TRANSMITTAL

Project Description: Replacement Senior Citizen Center Construction

RE: Change Order #43 **fully executed**

**LEXINGTON-FAYETTE URBAN COUNTY
GOVERNMENT CONTRACT CHANGE ORDER**
Page 1 of 2

LFUCG Senior Center
 REVISIONS TO GRADING AT DETENTION BASIN
 L10.0

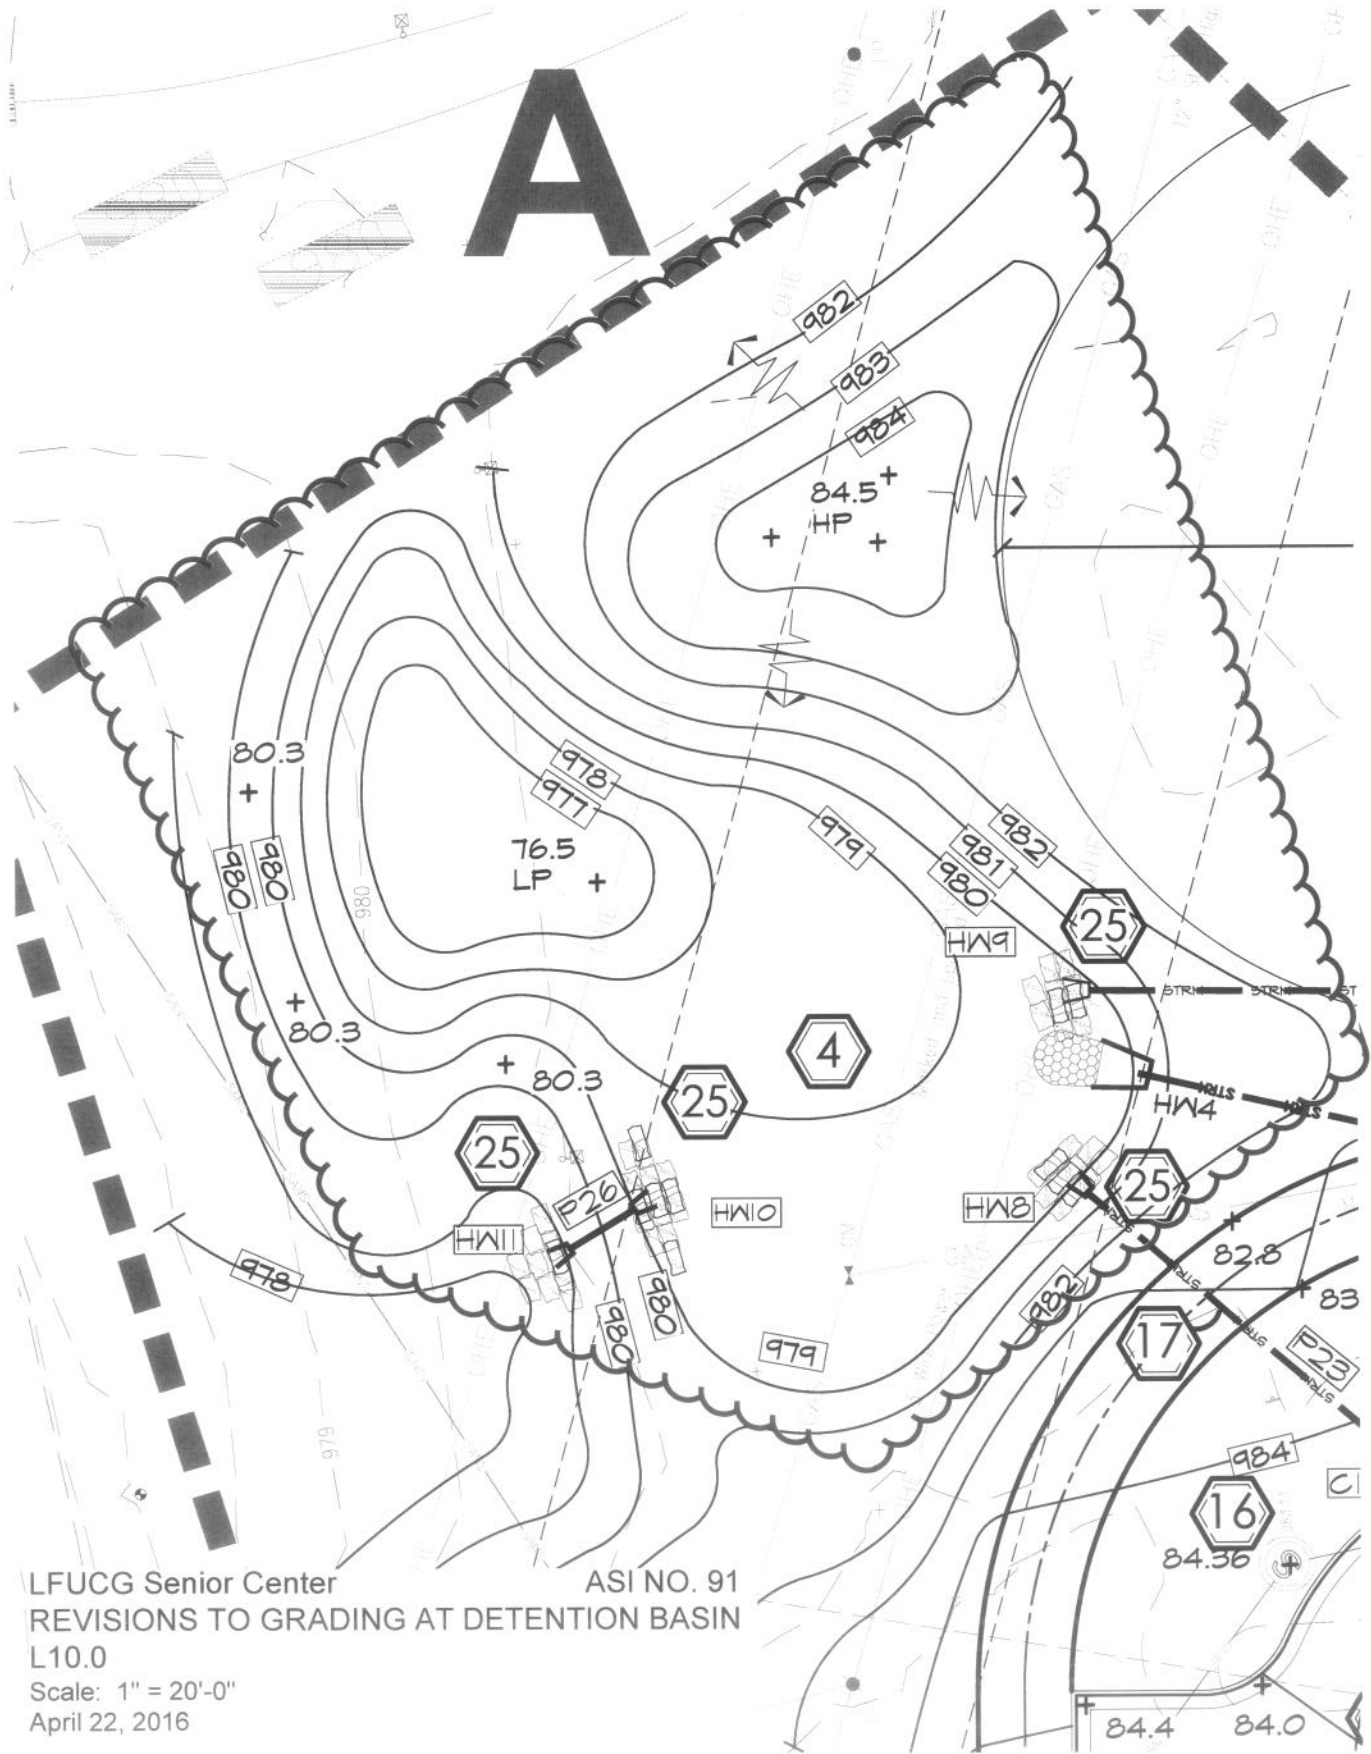
To avoid the high pressure gas line easement, please revise grading for the detention basin as described in the attached sketch.

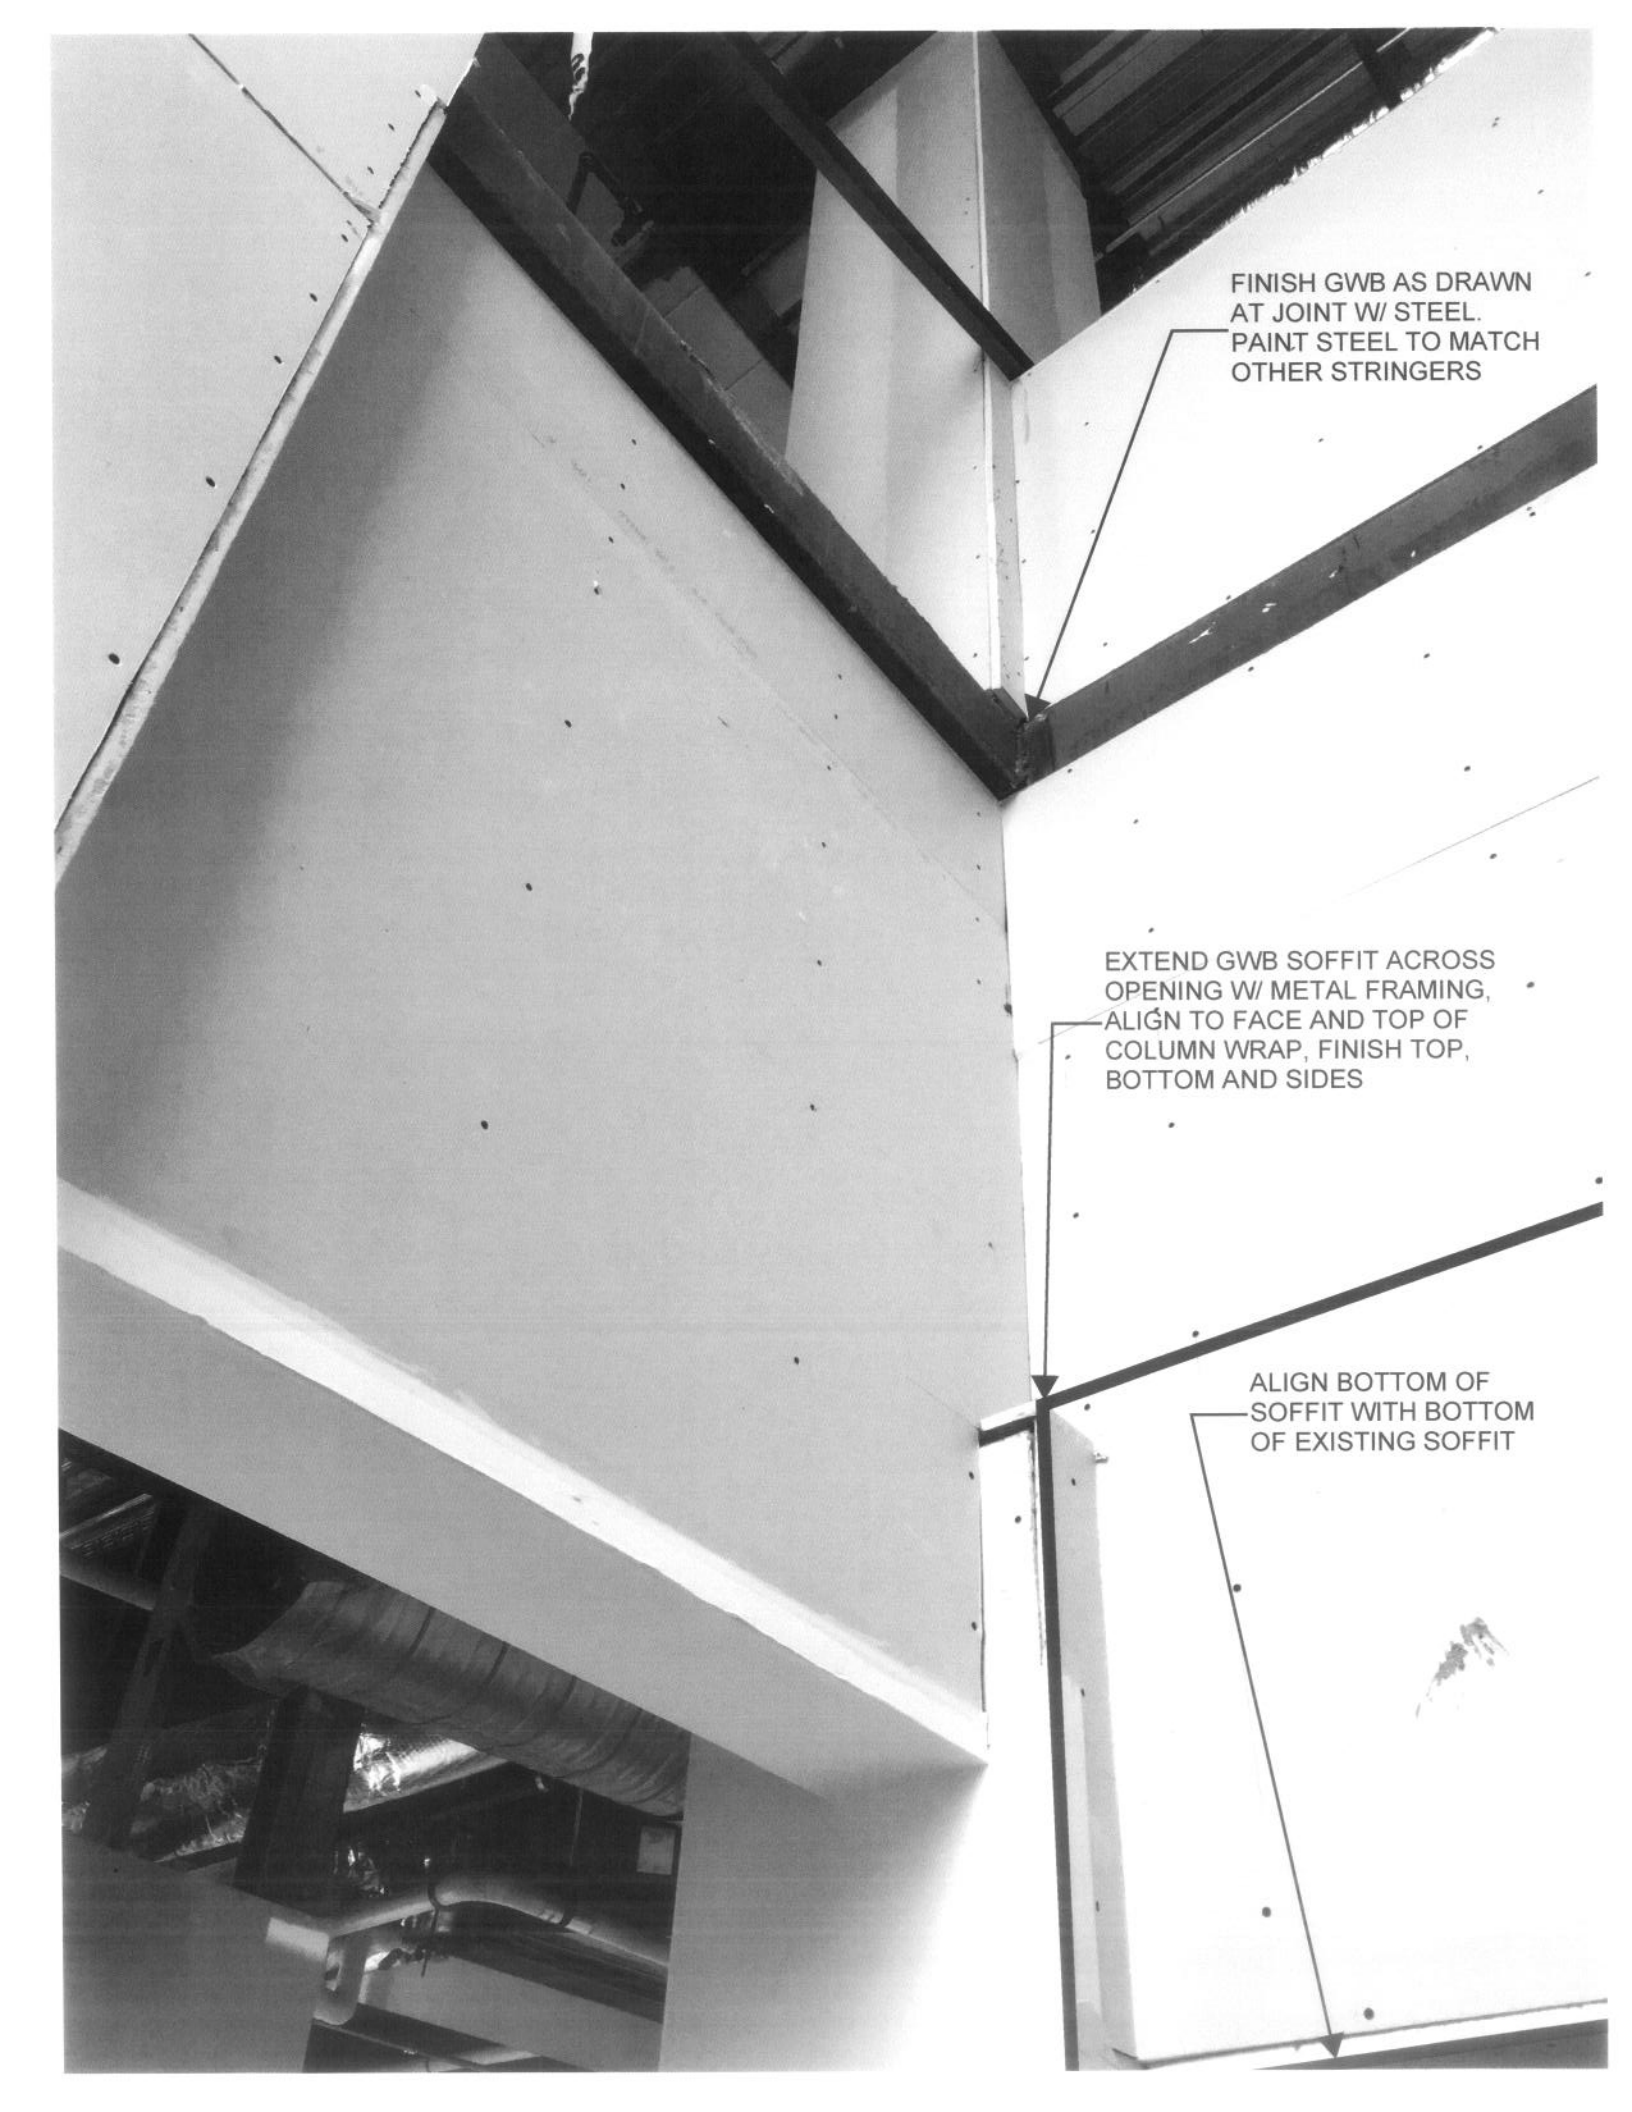
Please provide pricing to extend a soffit across the north flight of the west stair. Please refer to the attached annotated photograph for extents of soffit and alignments to existing work.

FINISH GWB AS DRAWN
AT JOINT W/ STEEL.
PAINT STEEL TO MATCH
OTHER STRINGERS

EXTEND GWB SOFFIT ACROSS
OPENING W/ METAL FRAMING,
ALIGN TO FACE AND TOP OF
COLUMN WRAP, FINISH TOP,
BOTTOM AND SIDES

ALIGN BOTTOM OF
SOFFIT WITH BOTTOM
OF EXISTING SOFFIT

C1.0, PR 044

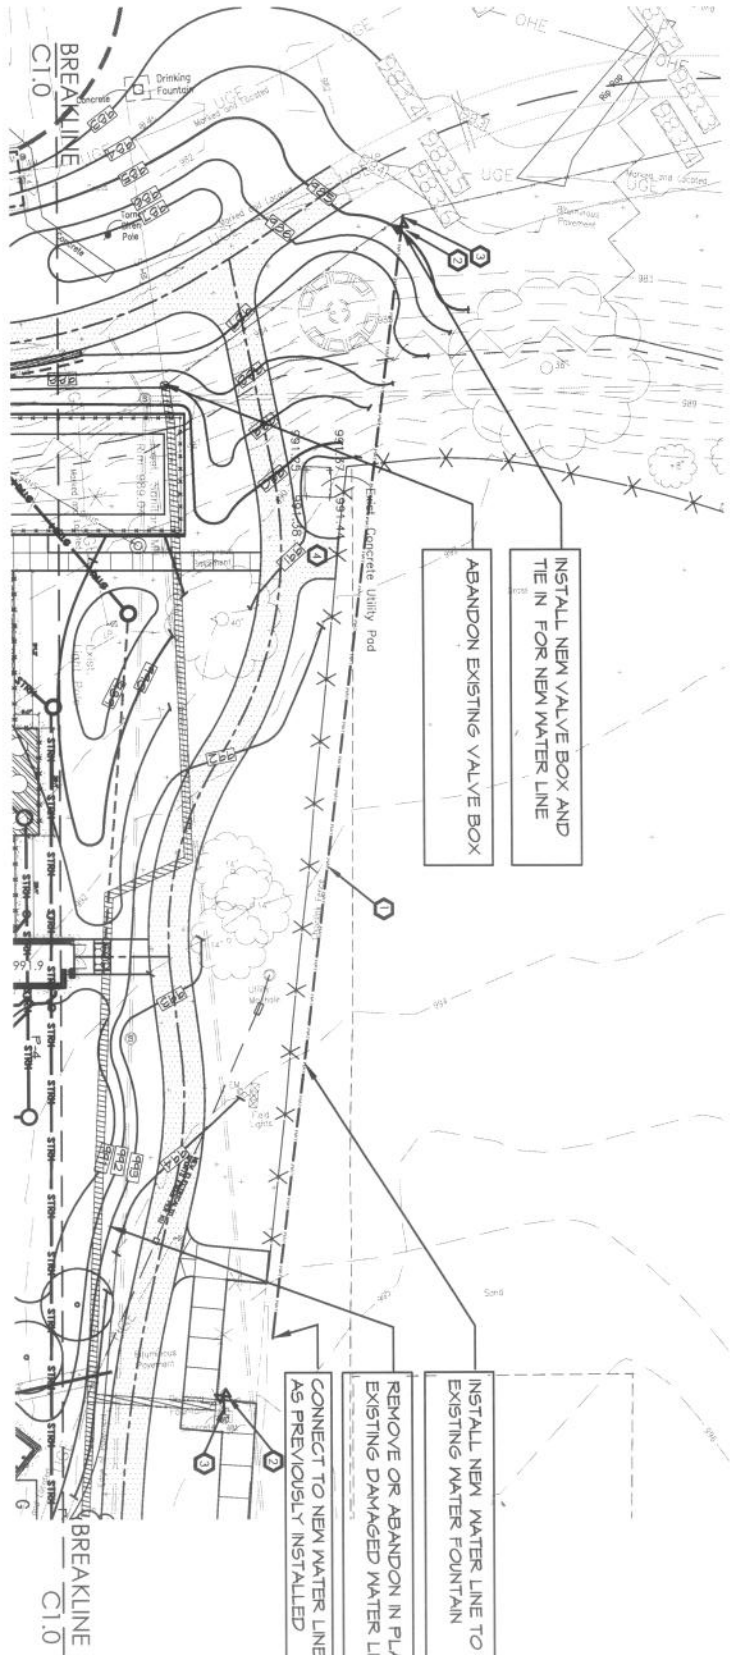
Please provide pricing to establish a new connection from the private water line to the existing outdoor drinking fountain, as described in the enclosed sketch. Notes on the work include:

- Existing valve box near the corner of the pickleball court is too deep to be serviceable. Connection is to be abandoned.
- Existing damaged water line to be abandoned in place, except where removal is required to complete other work in the contract.
- New valve box, piping, and other associated structures shall be installed per the original contract documents (see sheet C2.0)
- Please provide pricing breakdown, including materials and labor (w/

- 1 PROVIDE 1" PVC WATER LINE. REFER TO DETAIL C, SHEET C2.0. PROVIDE TRACER WIRE.
- 2 PROVIDE GATE VALVE. REFER TO DETAIL D, SHEET C2.0.
- 3 CONNECT TO EXISTING PRIVATE WATER SERVICE LINE.
- 4 BACKFILL TRENCH IN THIS LOCATION WITH DGA TO PROTECT LINE PRIOR TO INSTALLATION OF NEW ACCESS DRIVE.
